# *City of Albuquerque*

August 18, 1994

RE: GRADING & DRAINAGE PLAN FOR RAMADA INN (K-10/D25)  
RECEIVED AUGUST 5, 1994 FOR BUILDING PERMIT APPROVAL  
ENGINEER'S STAMP DATED 8/4/94

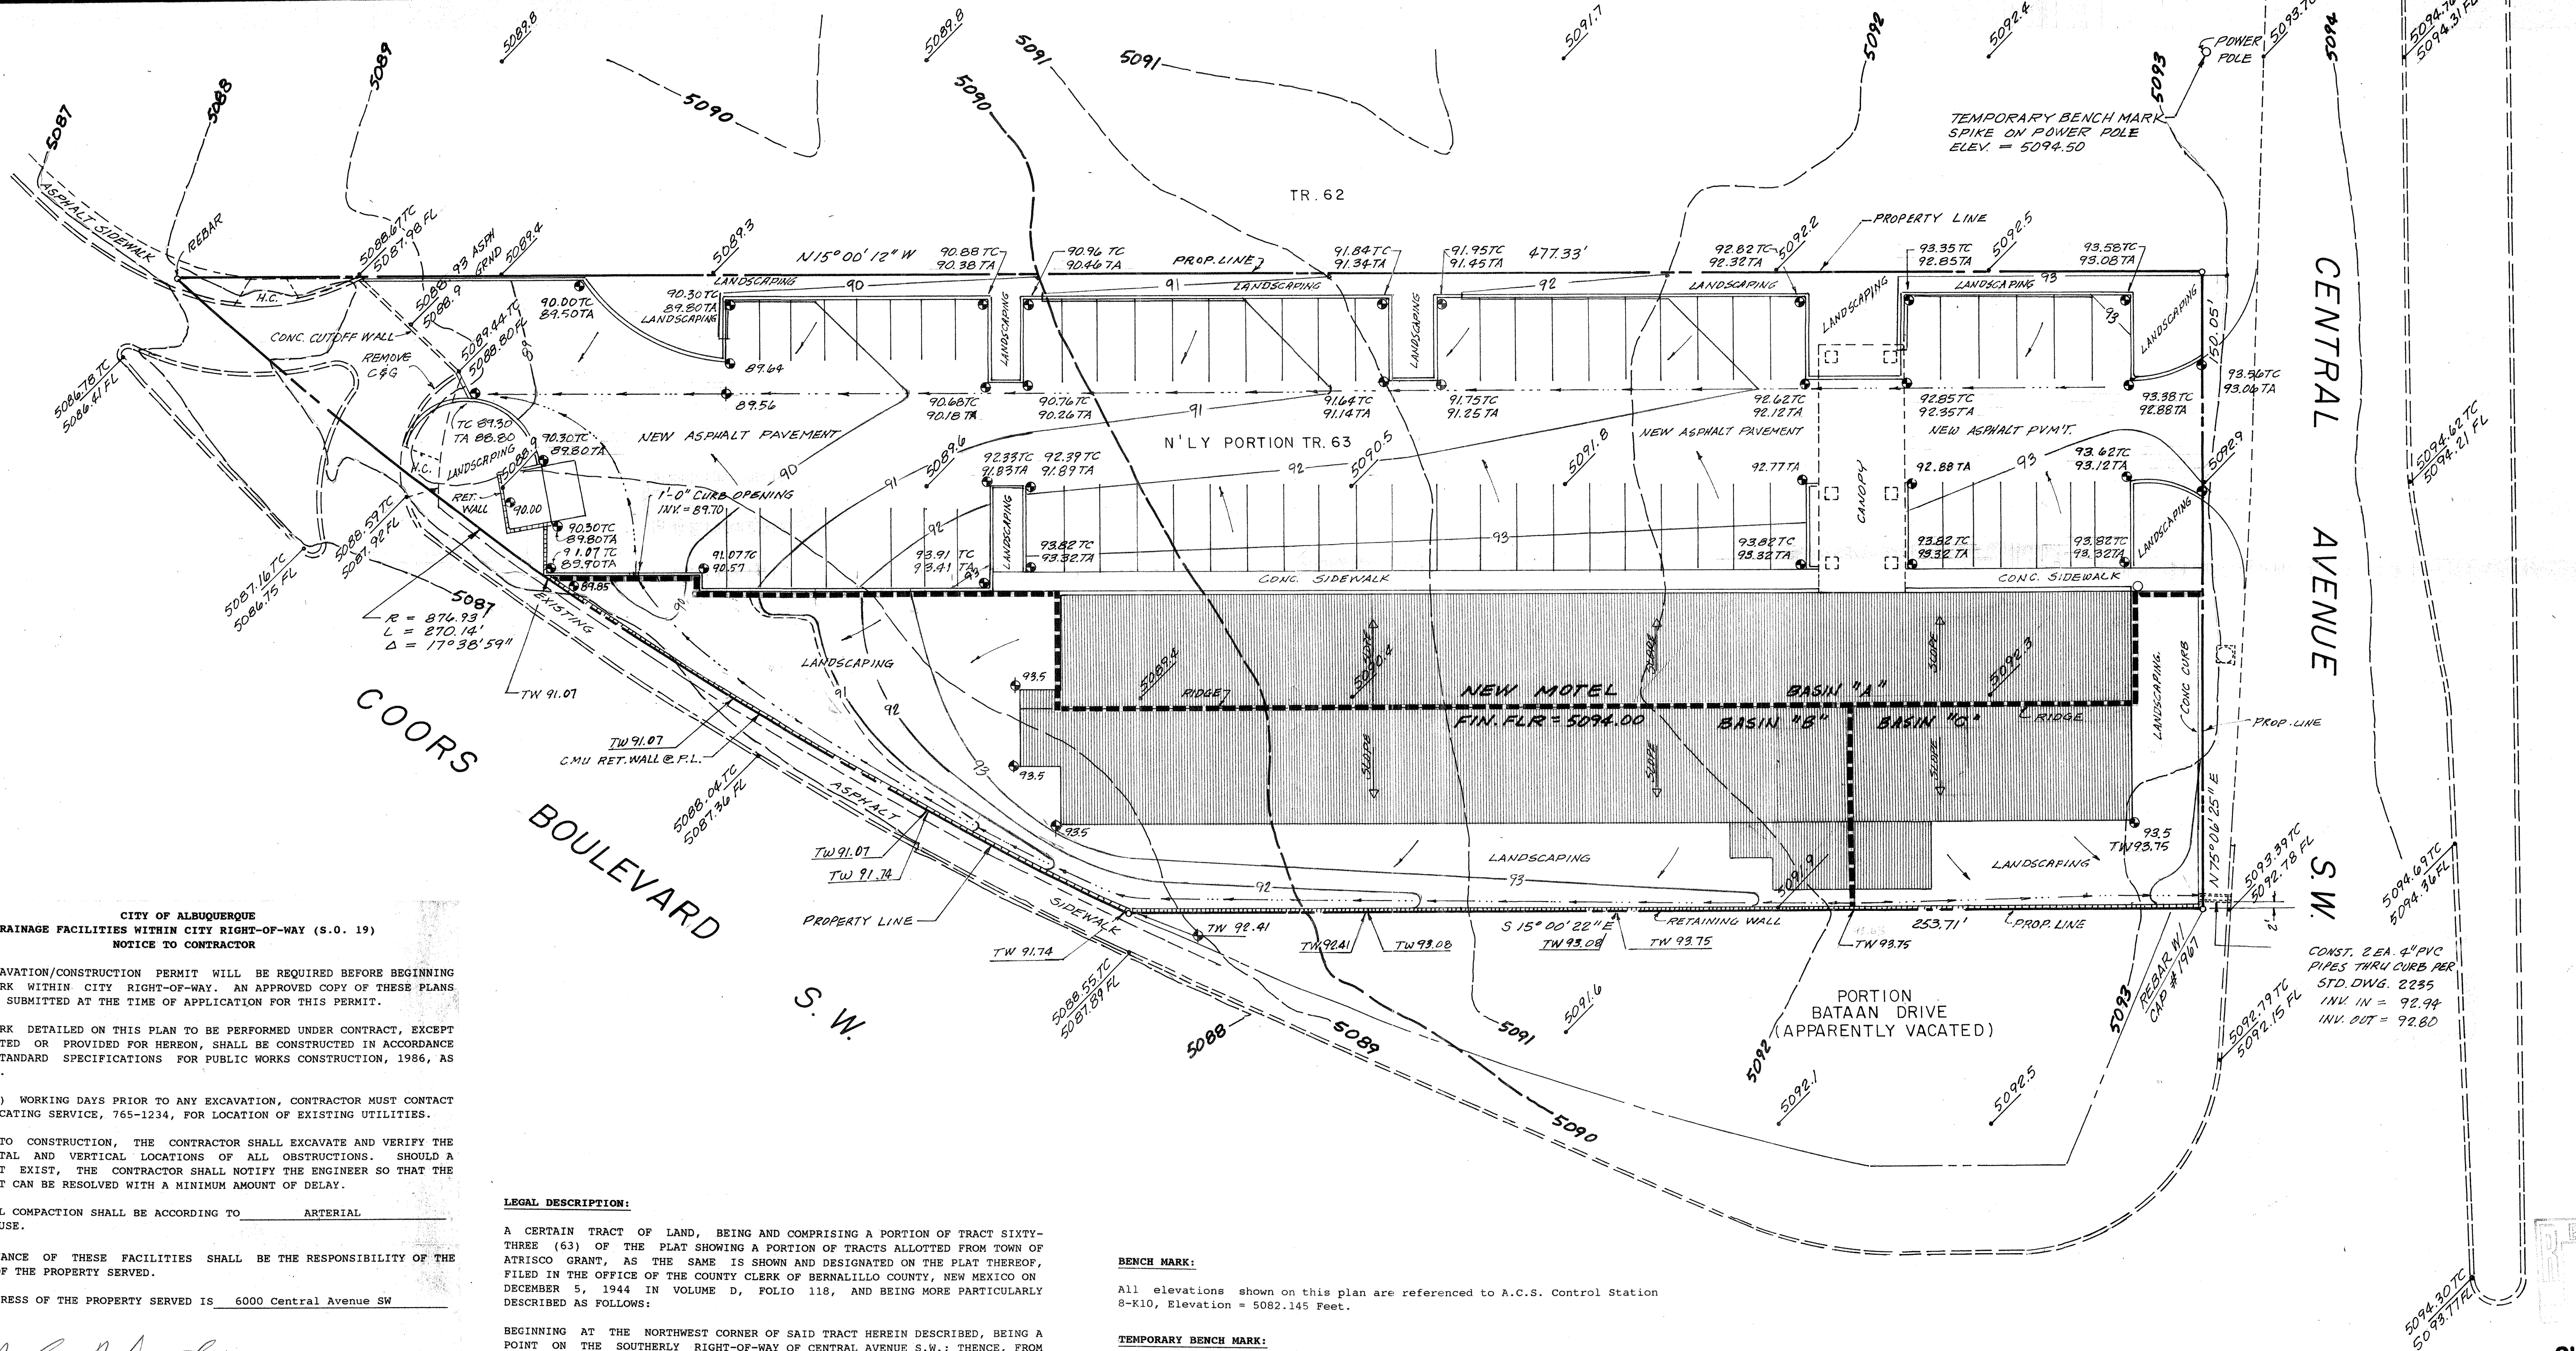
**RESPONSE TO LETTER OF JULY 27, 1994 FROM JOHN P. CURTIN, P.E.**

- The peak flow values quoted were found on page 17 of the Boyle Engineering Investigation Phase Report. In comparing the peak values from Table 4 or 6 with the capacity of the storm sewer outfall (See "Analysis of Downstream Conditions") the capacity appears to be adequate even for the values in Table 4 or 6.

- The City of Albuquerque Project No. for the North-South Coors Connection is 1893. The first inlets are approximately 1,000 ft. south of Central Avenue, or 420 feet south of the site, although there is one inlet behind the curb approximately 170 feet south of the site. The area north and west of the Coors North-South Connection that would drain to the inlets is conservatively estimated to be 4.5 acres. Assuming 10%, 20% and 70% for Land Treatments B, C and D, respectively,  $q_{100} = 0.1 \times 2.03 + 0.2 \times 2.87 + 0.7 \times 4.37 = 3.63 \text{ cfs/ac.}$   $Q_{100} = 4.5 \times 3.63 = 17.24 \text{ cfs.}$  From page 72 of the DPM, Street Capacity for a 48' street,  $Q = 9 \text{ cfs}$  half street flow. Slope = 0.0050'/ft., the depth of flow is 0.5'. The velocity is approximately 2.2 fps for that depth of flow. For practically any depth of flow the minimum velocity is about 1.0 fps. Therefore, the site peak discharge would reach the inlet in  $420/60 = 7$  minutes. The runoff from the site will be in the inlets before peak flow occurs in the street.

- The total discharge from the site is only 4.95 cfs. Since there is adequate capacity in the street and since the storm inlets are very near the site, ponding a portion of the runoff from this site would not result in any significant downstream flow reduction.
